PJM Interconnection, L.L.C.  
Docket No. ER17-2081-000

Reference: Amended Wholesale Market Participation Agreement

*Re: PJM Interconnection, L.L.C. Docket No. ER17-2081-000  
Amendment to Service Agreement No. 3247; Queue No. W1-120*

**AGREEMENT TO AMEND**  
**By and Among**  
**PJM Interconnection, L.L.C.**  
**And**  
**NJR Clean Energy Ventures III Corporation**  
**And**  
**Jersey Central Power & Light Company**  
**(PJM Queue Position #W1-120)**

**ADDENDUM 1 – Changed From  
SCHEDULE A  
SINGLE-LINE DIAGRAM**

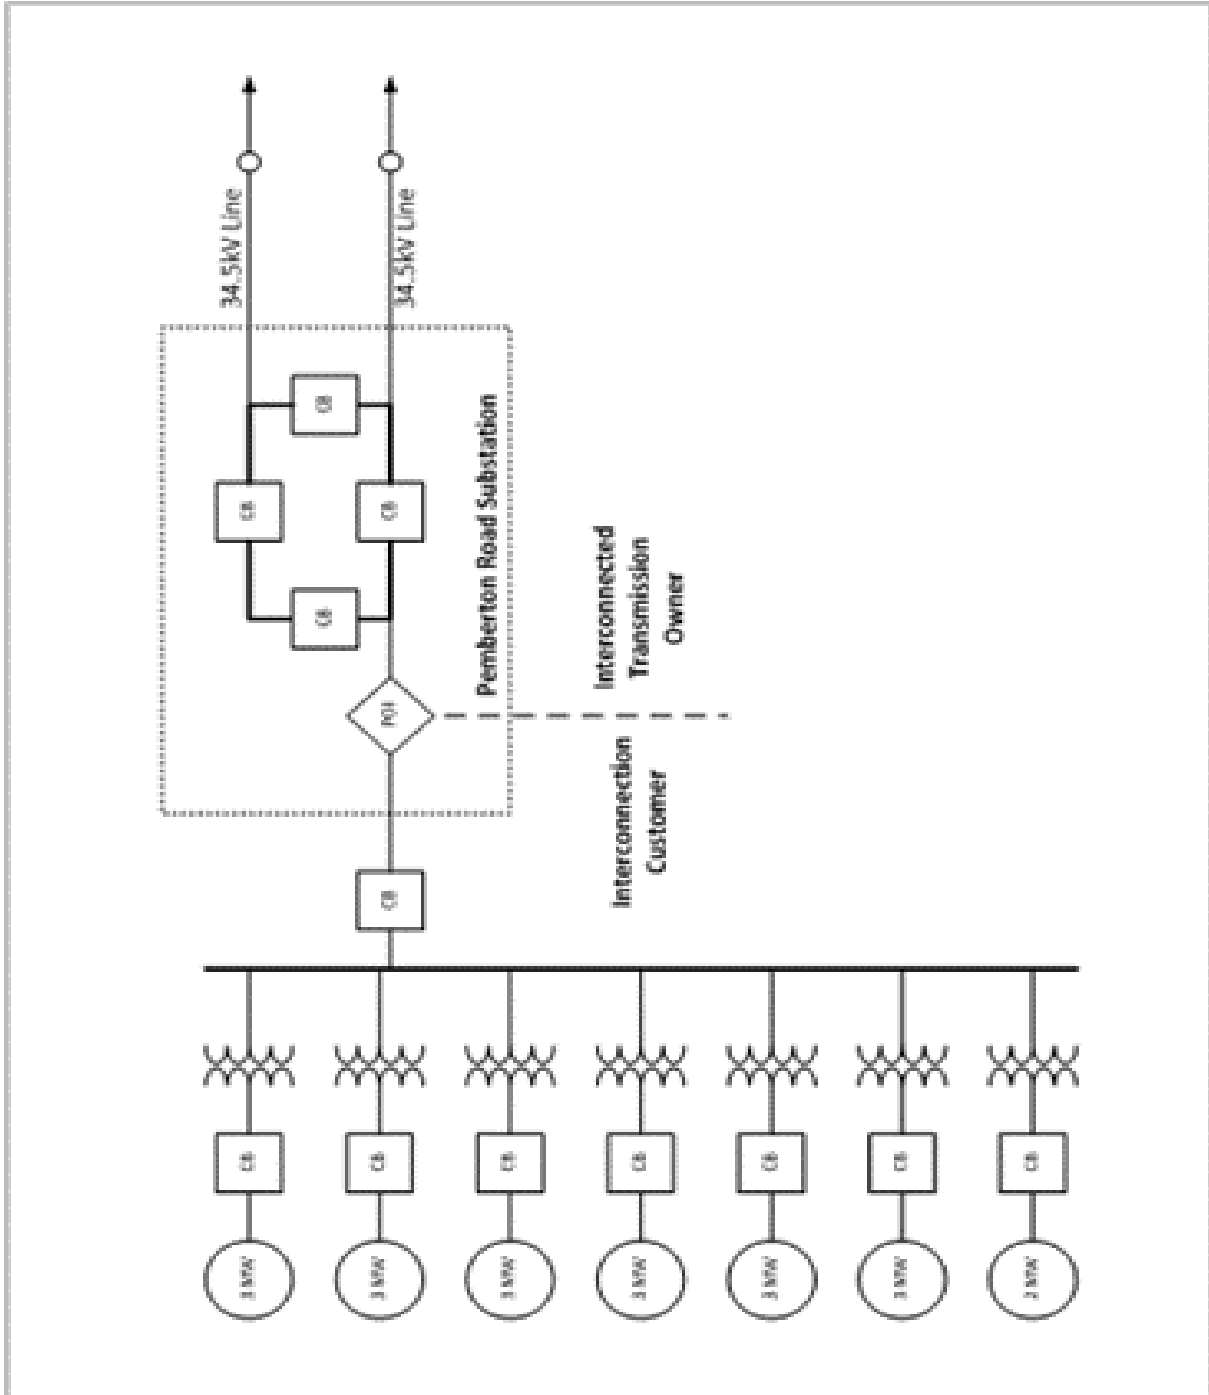
Interconnection Rights at the point(s) of interconnection specified in Schedule A of this Wholesale Market Participant Agreement in the amount of 7.6 MW	Interconnection Rights at the point(s) of interconnection specified in Schedule A of this Wholesale Market Participant Agreement in the amount of 3.34 MW	
Schedule A*	*See former single-line diagram attached as Addendum 1	*See single-line diagram attached as Addendum 2	The single-line diagram has been modified to reflect the change in the number of generating units.

### ADDENDUM 2 – Changed To SCHEDULE A SINGLE-LINE DIAGRAM
